SUBJECT: Addendum No. 1  
IFB No. 26M-0201 Maluhia Cooling Tower Replacement

## ADDENDUM NO.1

### **MALUHIA HOSPITAL COOLING TOWER REPLACEMENT**

Drawing Number  
**M101**

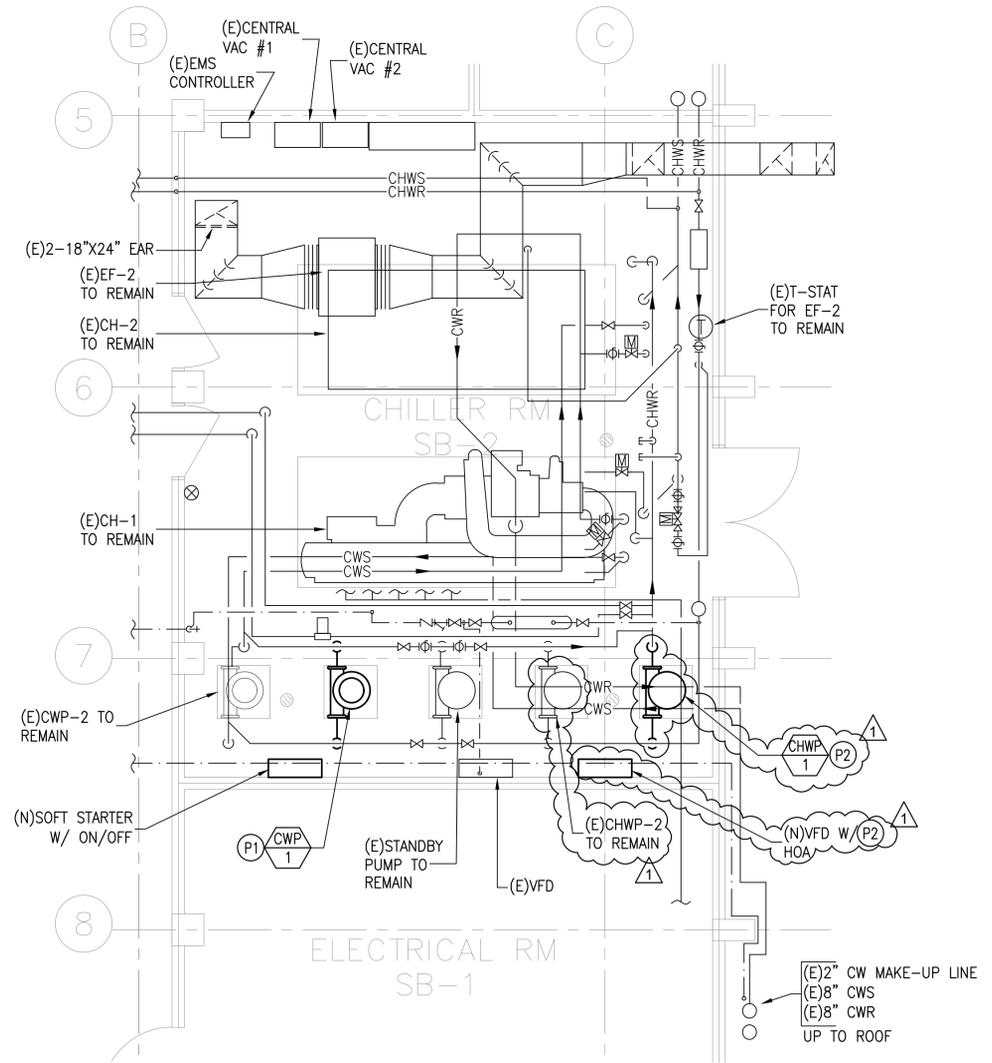
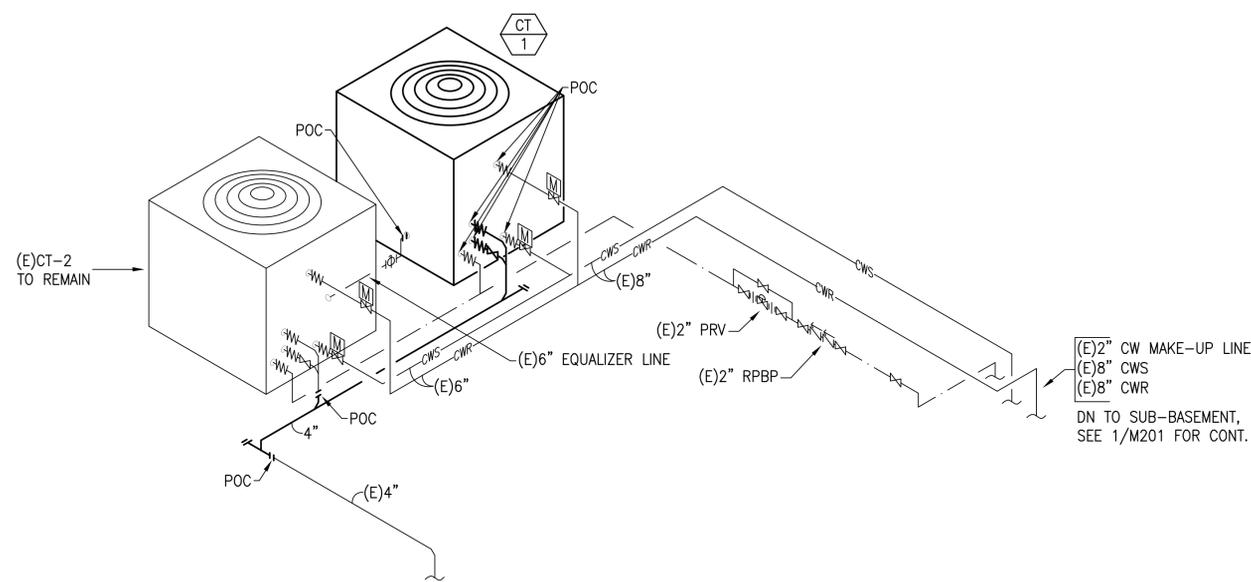
Correct Chilled Water Pump (CHWP)-2 to remain as existing, and revise CHWP-1 to be removed completely per revised demolition notes. Revised new floor plan to indicate CHWP-2 to remain as existing, and CHWP-1 to be a new pump with Variable Frequency Drive (VFD).

Drawing Number  
**M201**  
 Sheet No. 7 of 14

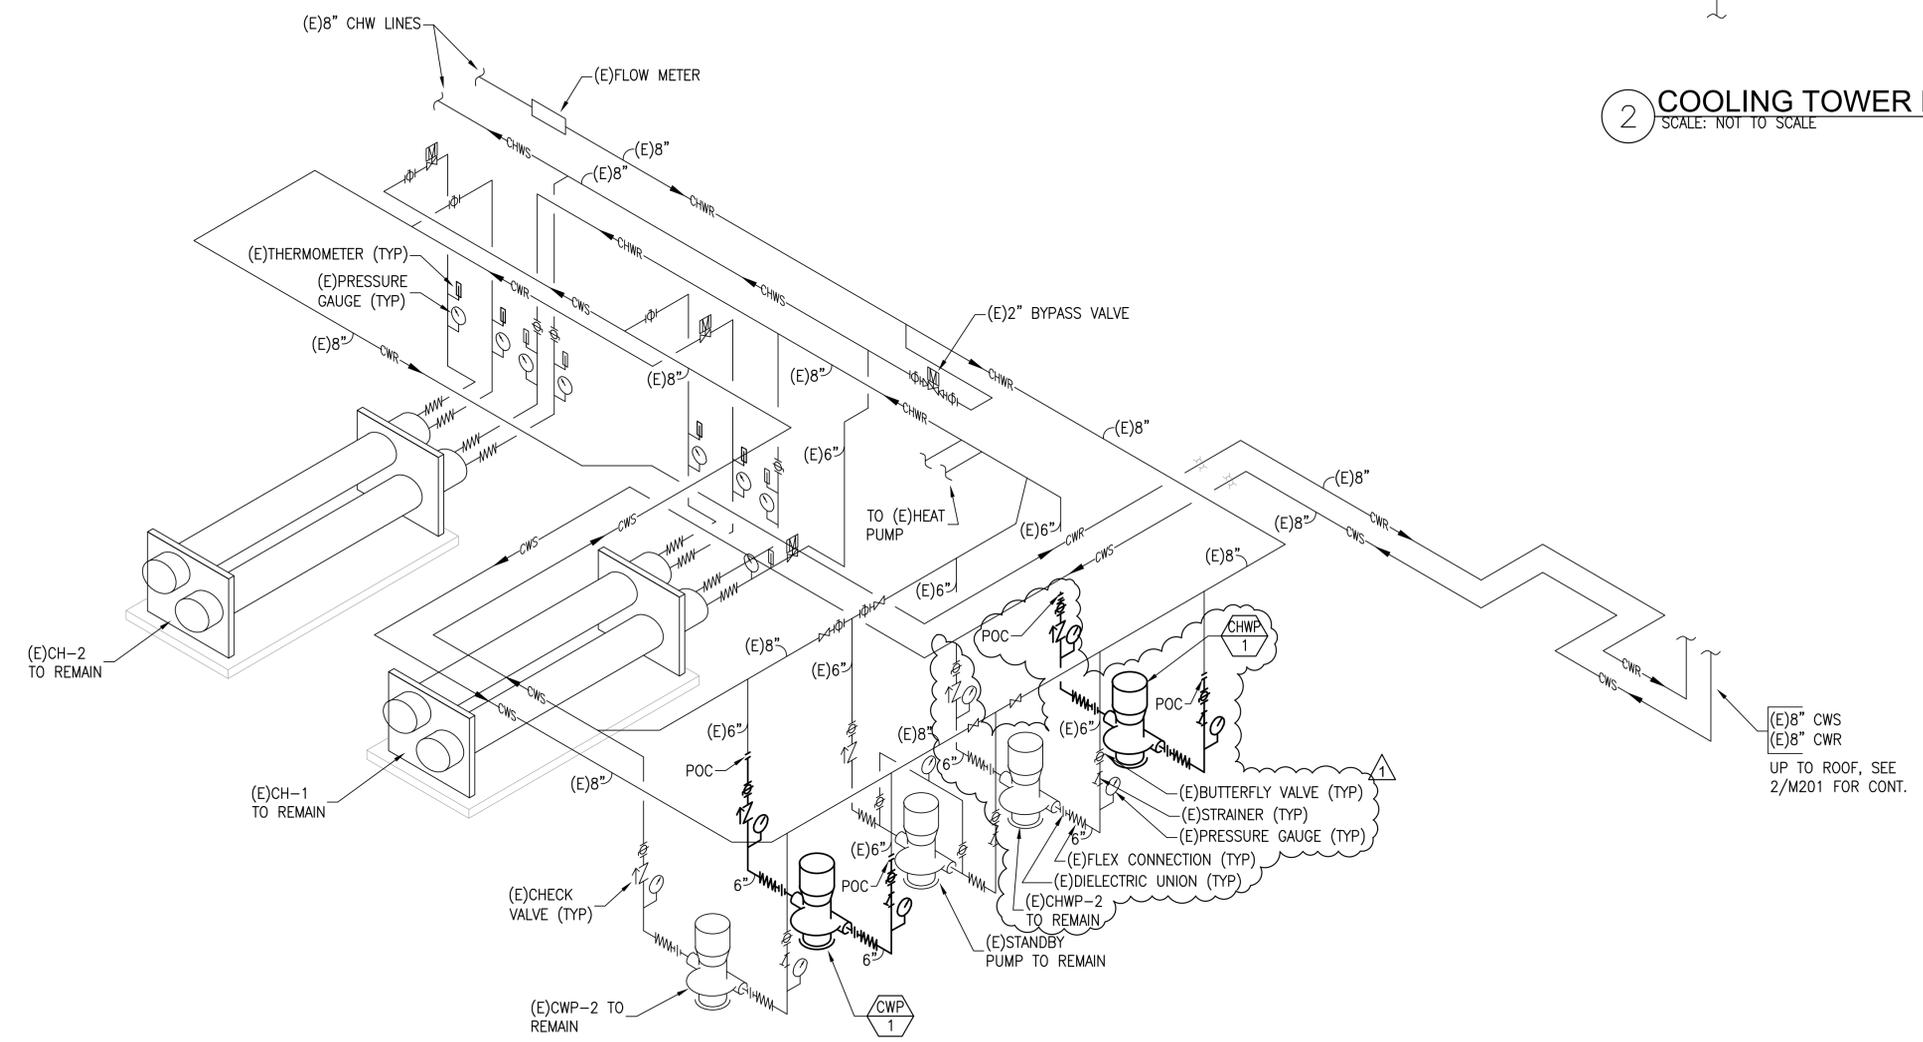
Correct Chiller Plant Diagram to match with floor plan.

M301

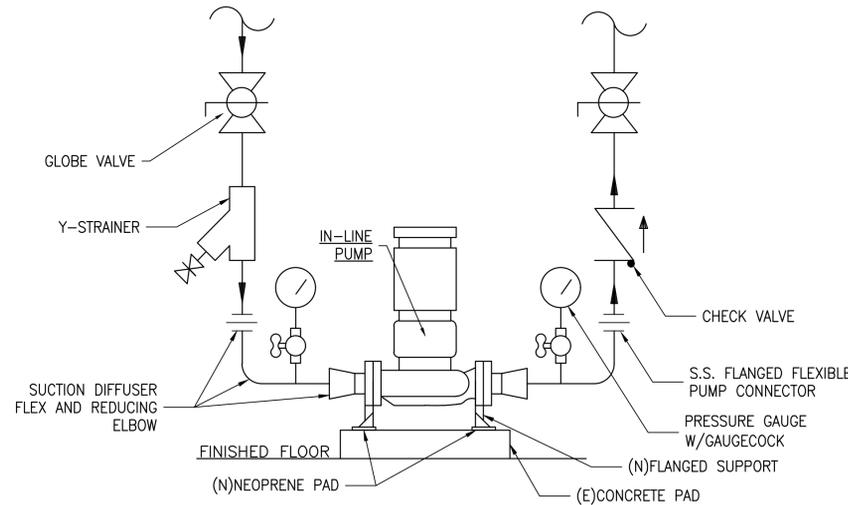
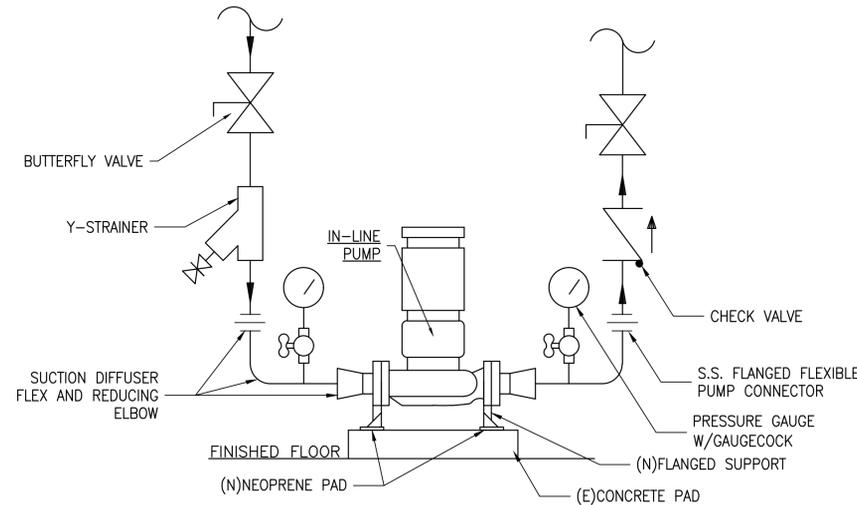
Revised Chilled Water Pump Schedule to show correct pump callout.

PARTIAL SUB-BASEMENT ELECTRICAL PLANS - DEMOLITION AND NEW WORK

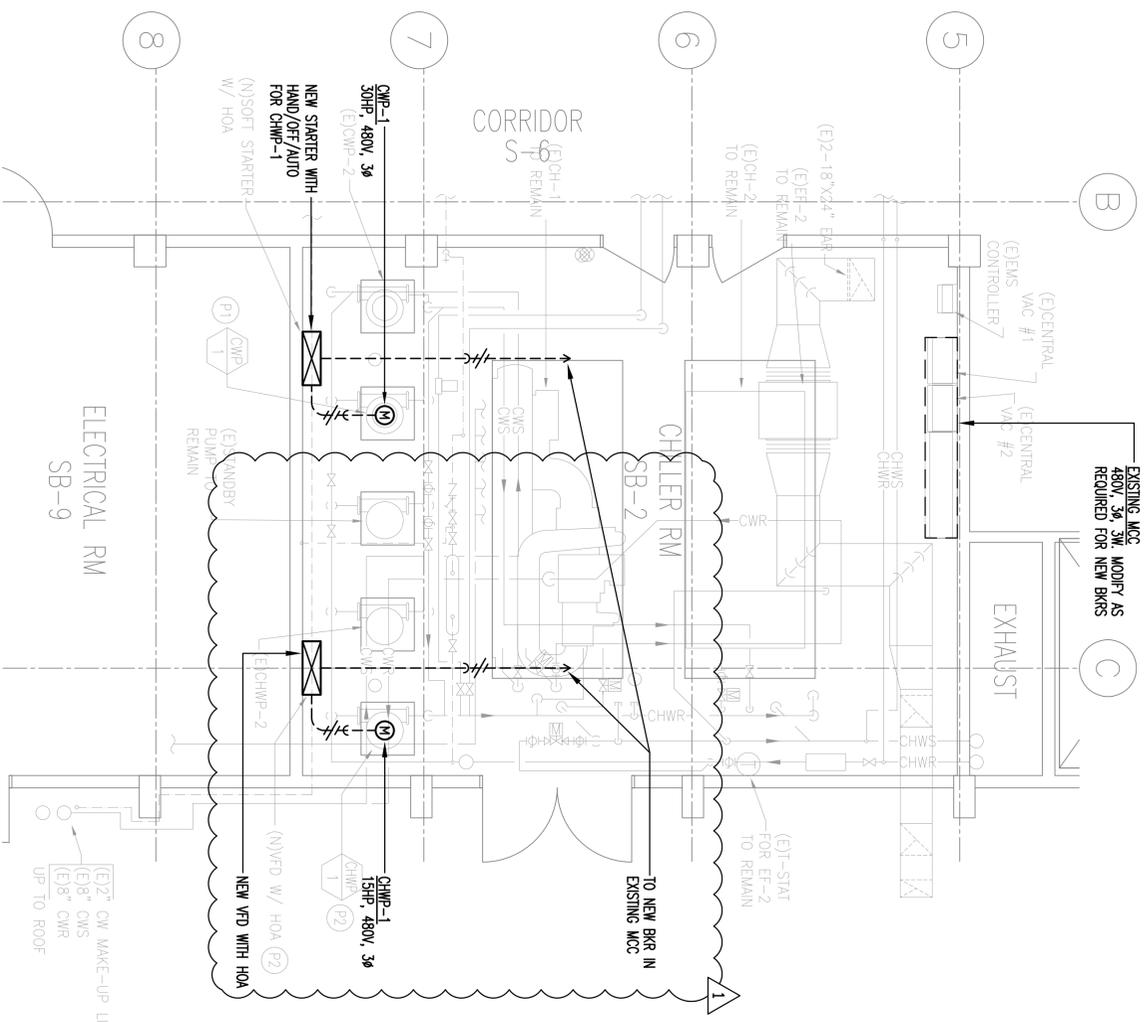
Revise demolition and new plan to match with mechanical changes.

SINGLE LINE DIAGRAMS - DEMOLITION AND NEW WORK

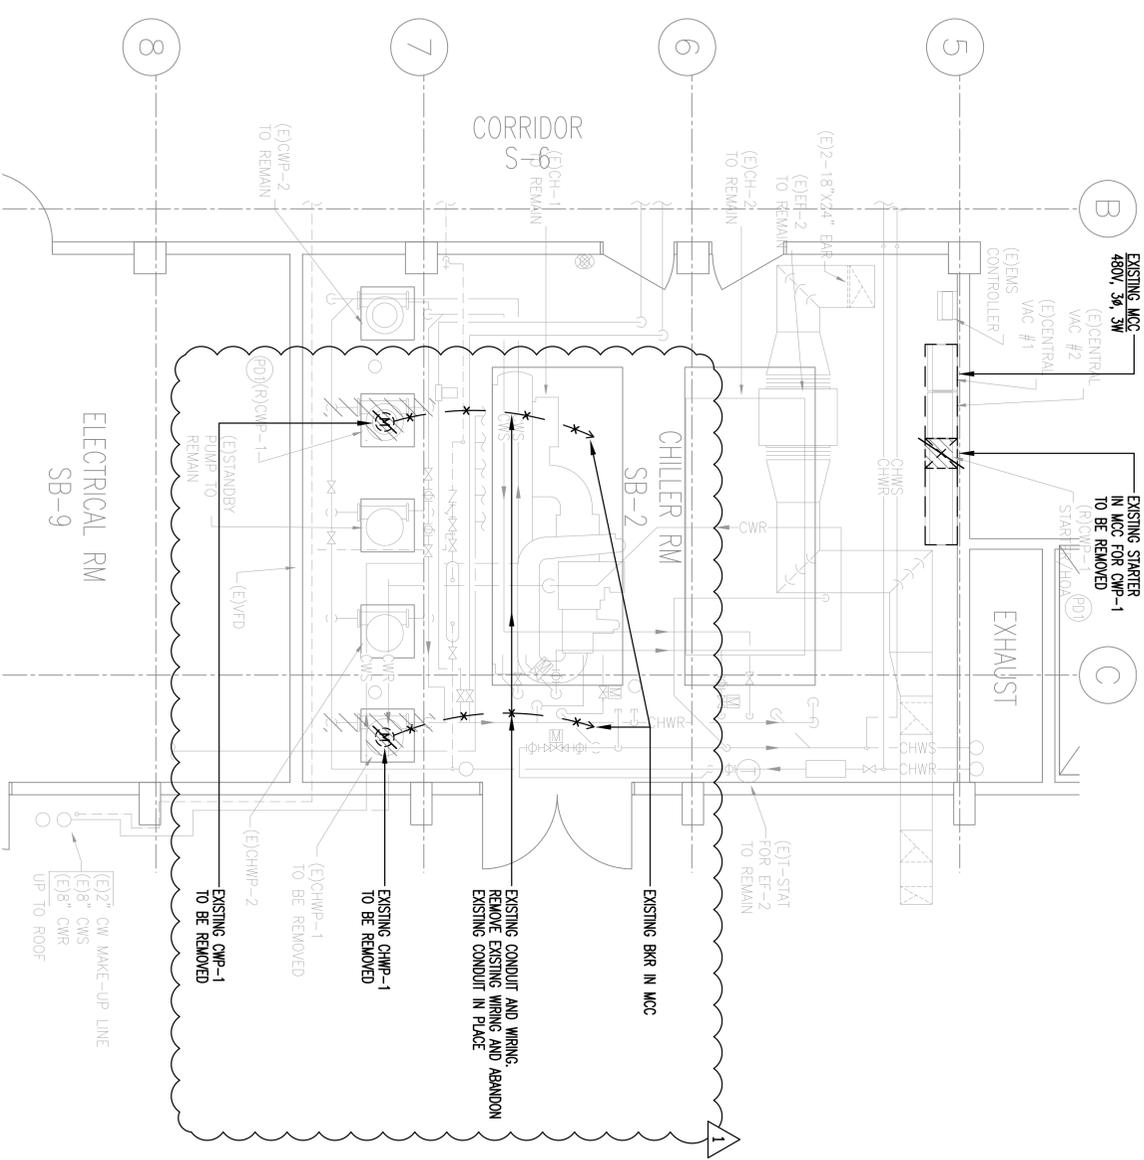
Revised single line diagram to reference correct pump per mechanical changes.
